Interactive comment on “One-way coupling of an integrated assessment model and a water resources model: evaluation and implications of future changes over the US Midwest” by N. Voisin et al.

We would like to thank reviewer #2 for the thorough review and constructive comments that have led to an improved manuscript.

Fig. 1.

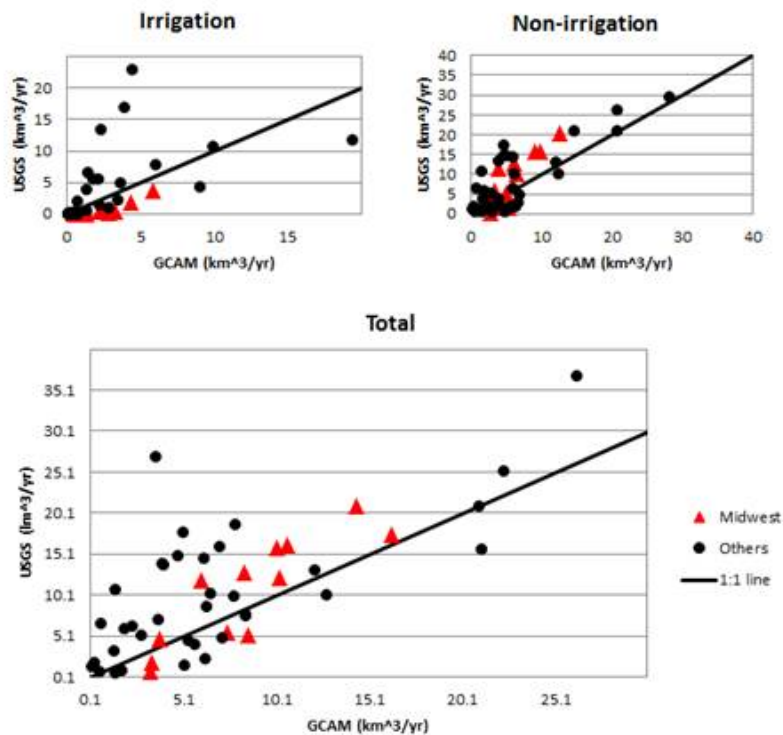
Comment 13: Figure 3: Could you provide in normal scale? We plotted figure 3 in normal scale, see below. The normal scale does not allow looking at outliers for the low and high values properly. We believe that the log scale shows best how GCAM and USGS compare over a range of values. (see figure at the end of the document)
